Change Order

Change Order No.: 28 CBCL Project No. 241016.00
Date: June 12, 2026
To: Alex Sawyer – Harbour Construction
Contract Name: Mahone Bay Edgewater Street Improvements
Contract No.: 241016.00
Refer To: 241016.00 CO28 Drawings C-400, C-401, C-402 & C-403
Copies To: Dylan Heide (Town of Mahone Bay)

EDGEWATER STREET IMPROVEMENTS

CLEARLAND ROAD SERVICING

PLAN & PROFILE CLEARLAND ROAD

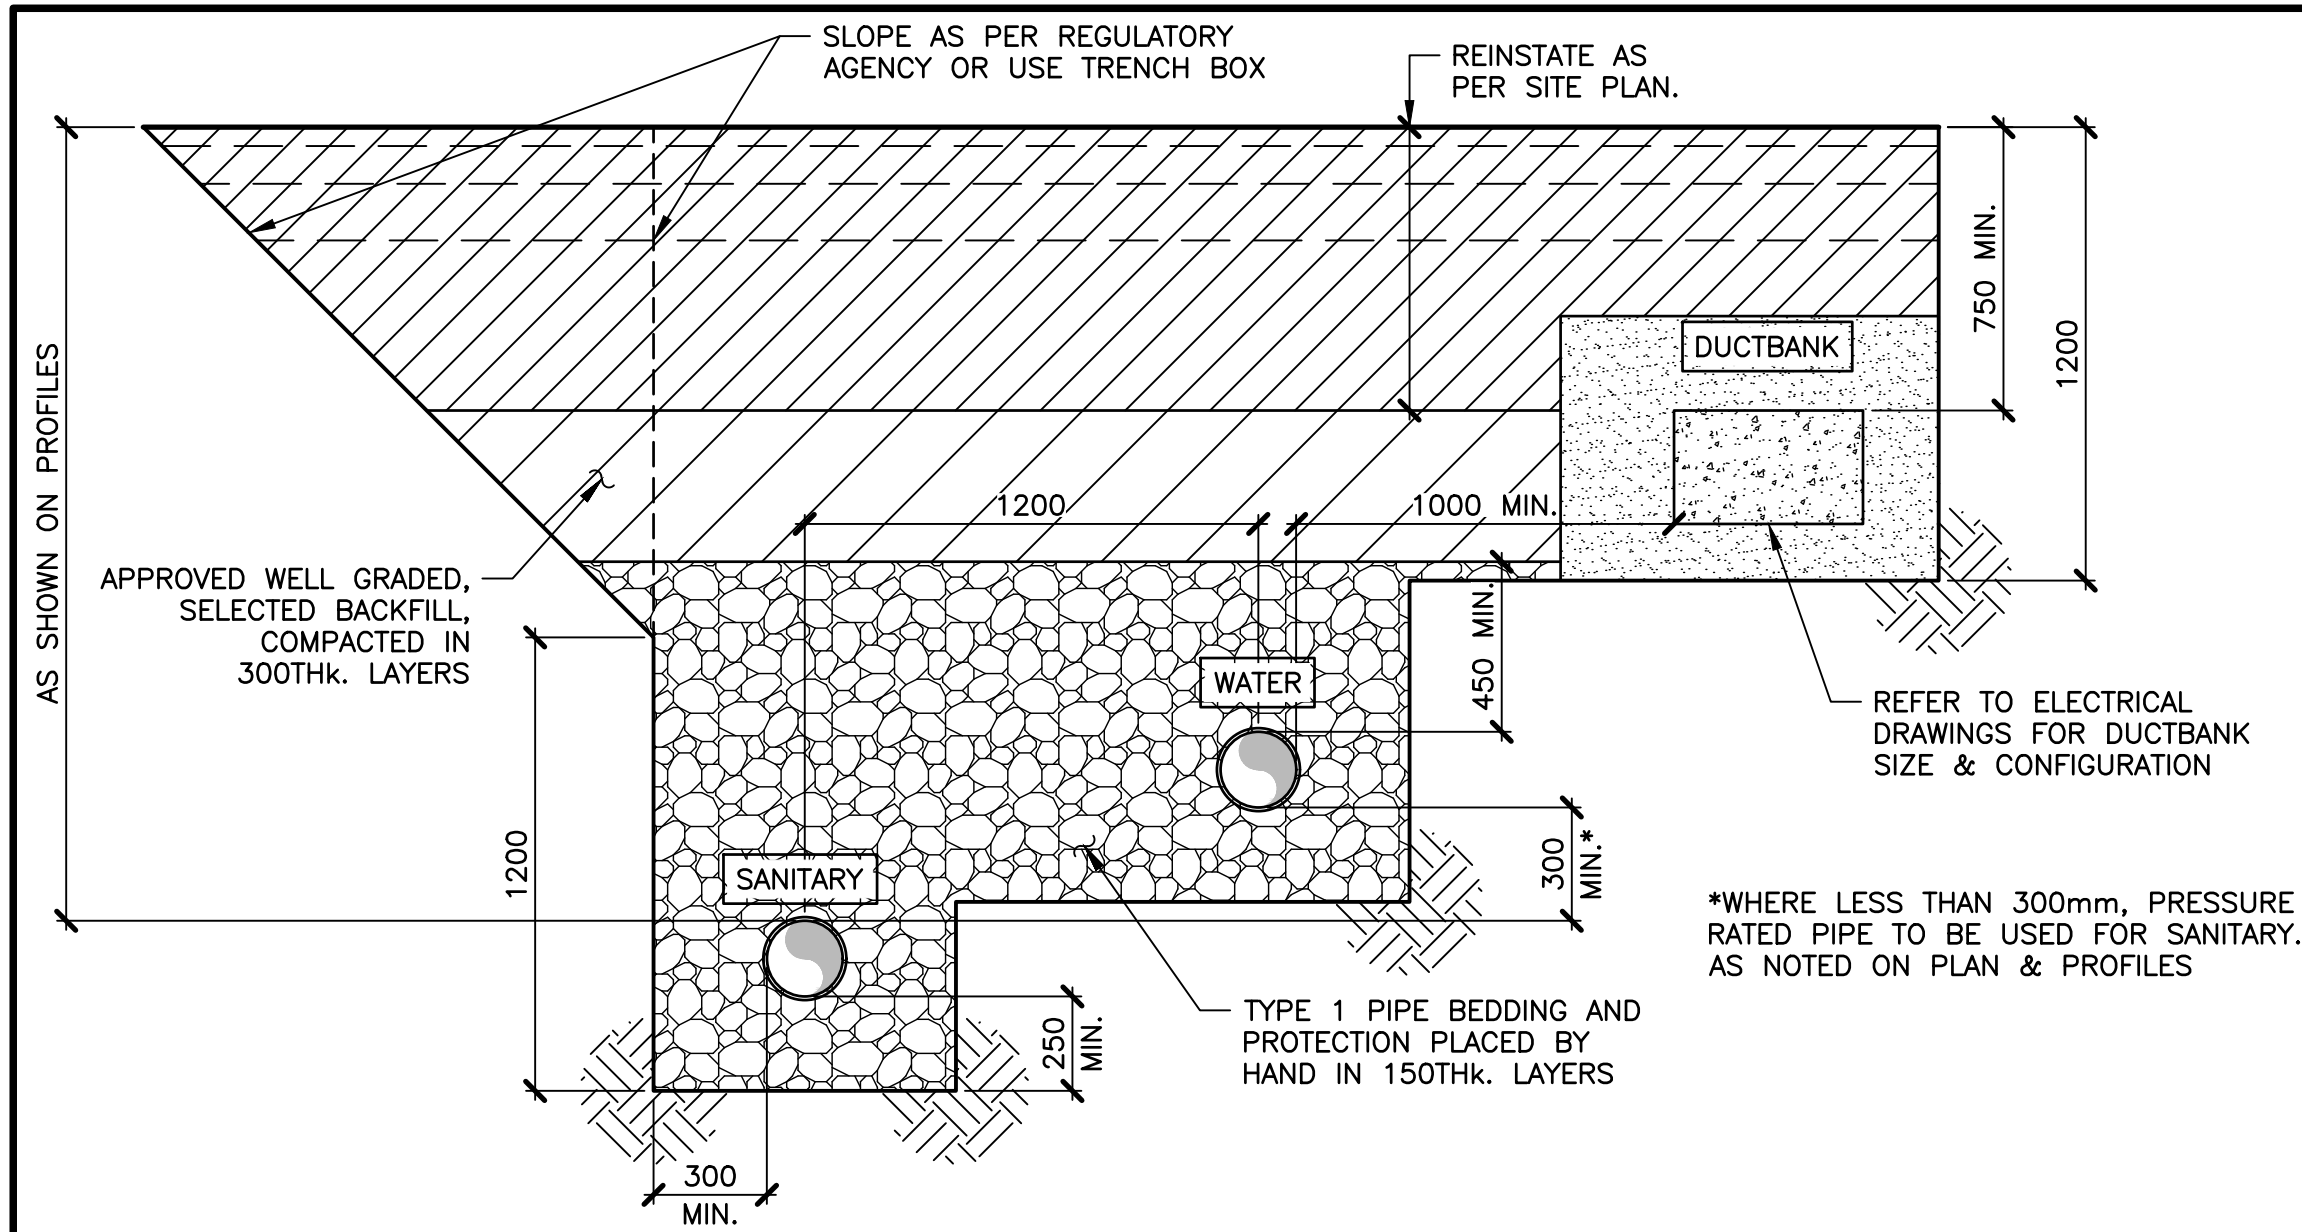
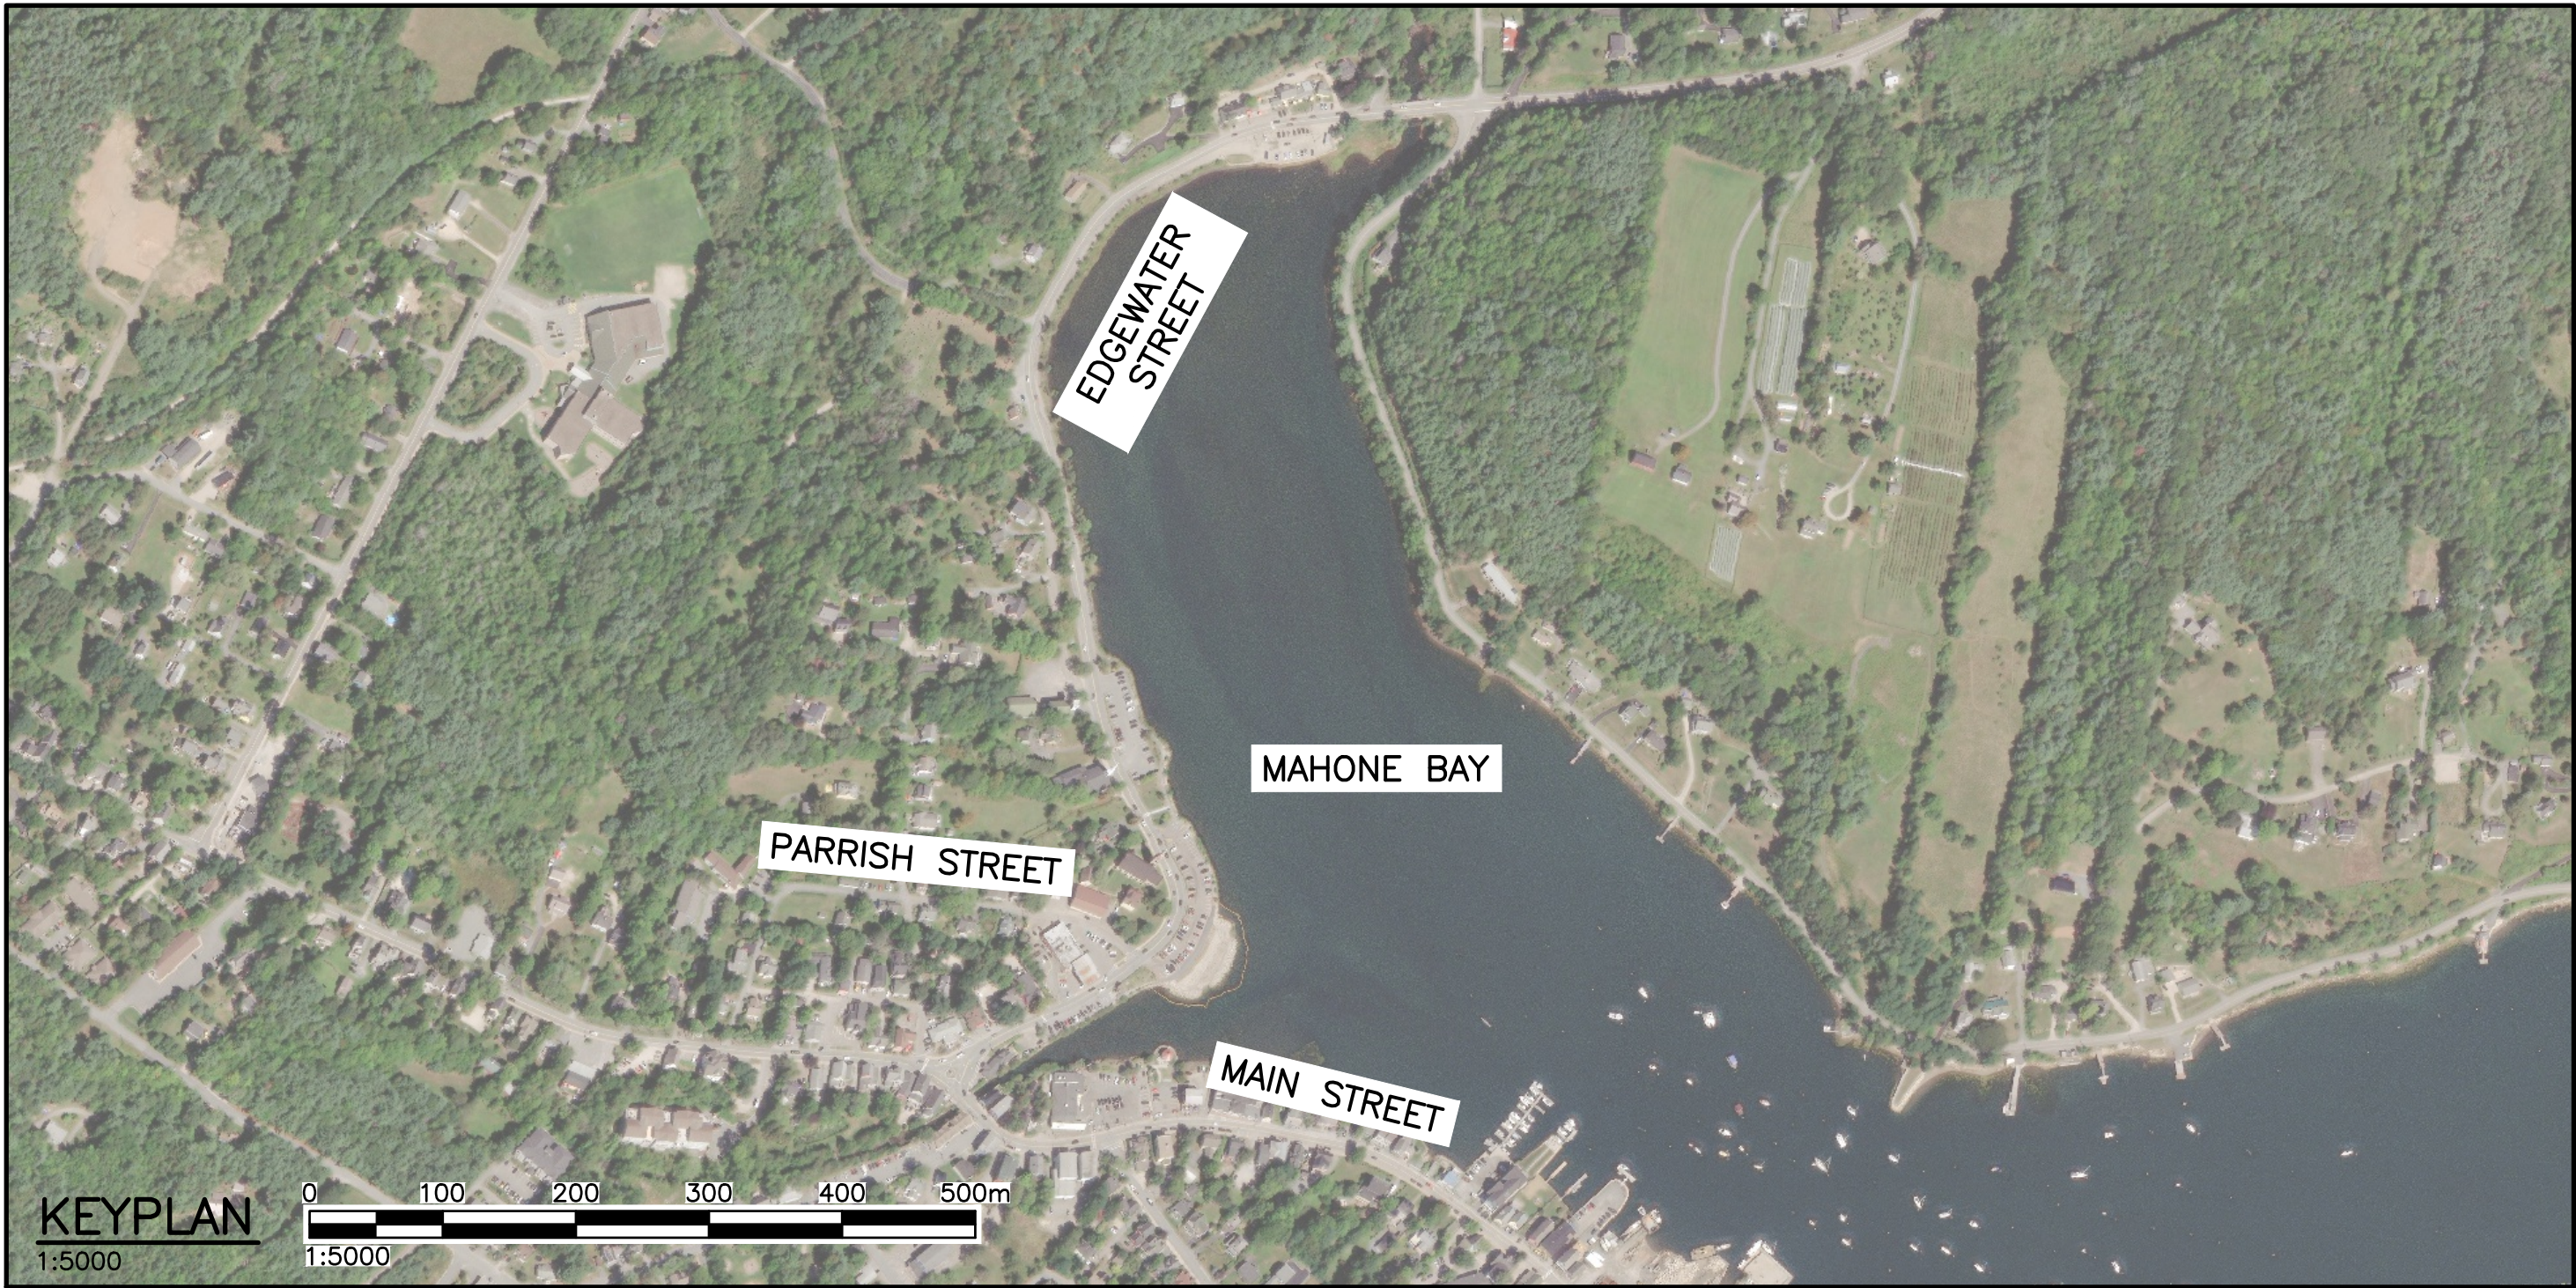
You are hereby authorized, subject to the provisions of your contract, to proceed with the following work: Clearland Road Servicing Extension Provide all labour, materials, equipment, and incidentals necessary to complete the extension of water, sanitary sewer, and electrical utility services for servicing of existing lots and future development areas, in accordance with the Change Order 28 drawings, Contract Documents, specifications, and details. Work includes all associated excavation, trenching, bedding, backfill, utility installation, tie-ins, testing, commissioning, surface restoration, and all appurtenant works required for a complete and functional installation. Import Common Fill Item 3.2.3 Import Common Fill (Provisional) - Addition of 347.59m3 @ \$102.75/m3 to compensate for all additional imported fill required to complete project scope. SUB-TOTAL	Credit	Extra
		\$ 1,200,000.00
